CRYSTAL RIVER UNIT 3 NUCLEAR GENERATING PLANT

AMENDMENT TO FACILITY OPERATING LICENSE

Amendment No. 41
License No. DPR-72

ATTACHMENT TO LICENSE AMENDMENT NO. 41

BASES FIGURE 2.1

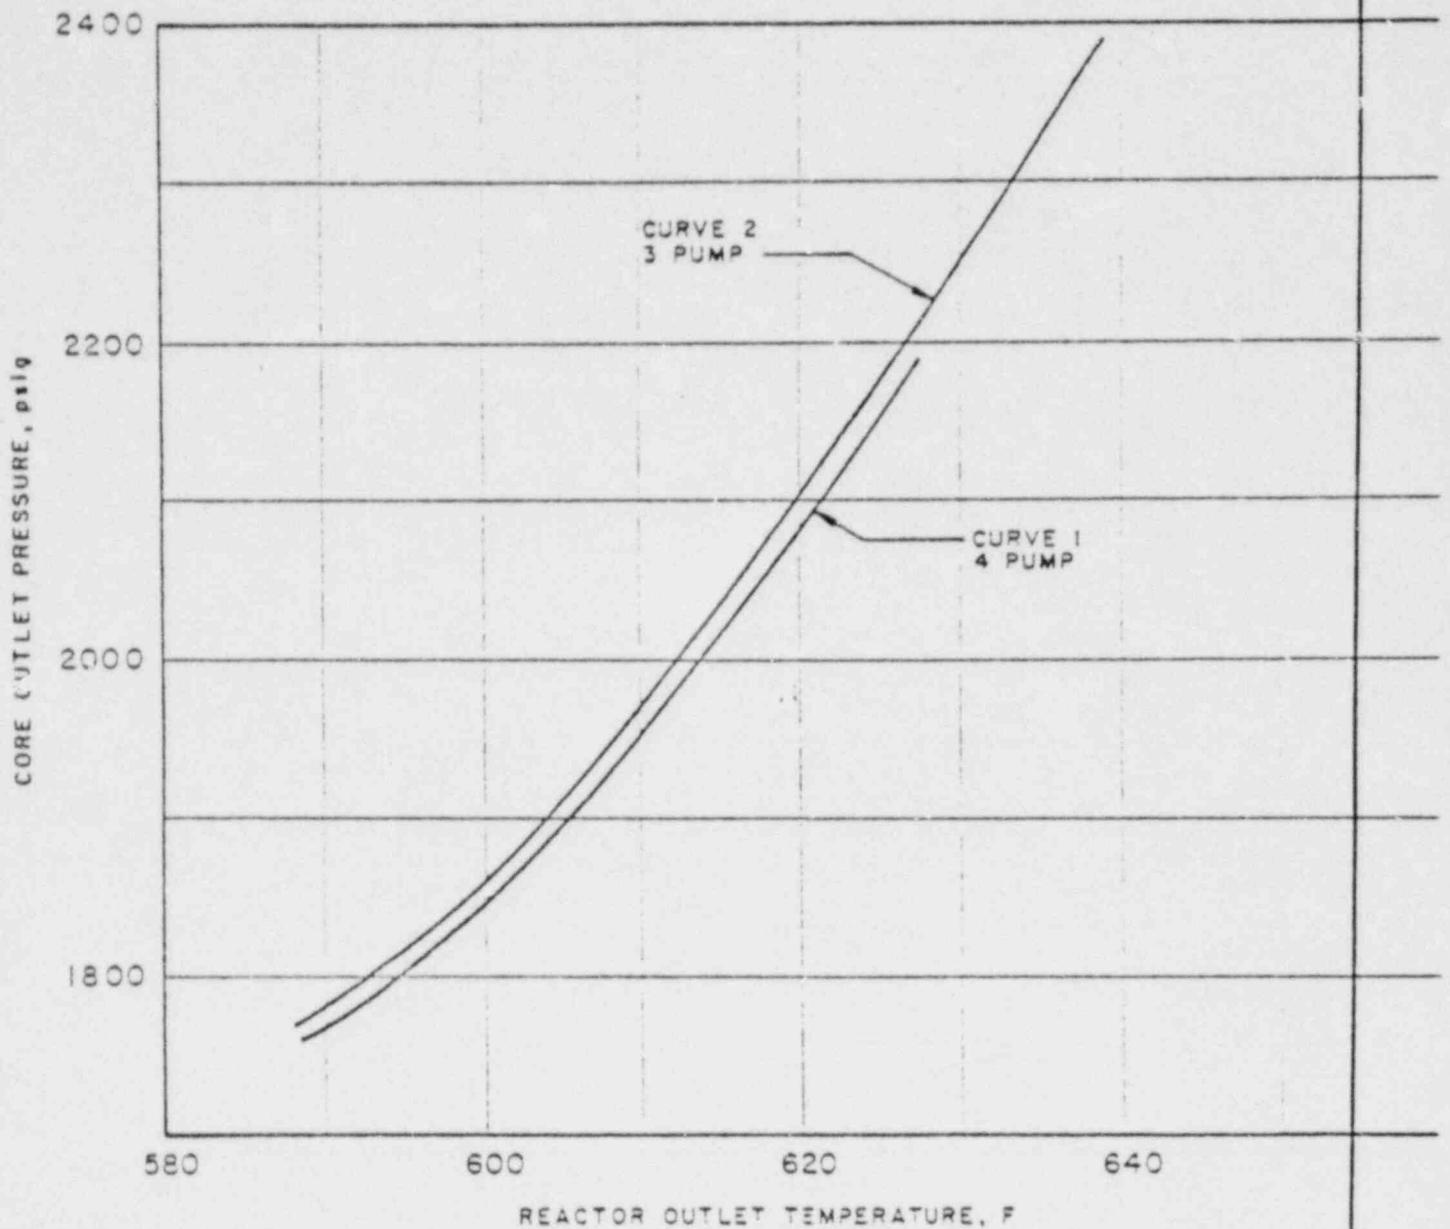
THIS FIGURE IS DELETED
FOR THE REMAINDER OF
CYCLE 3
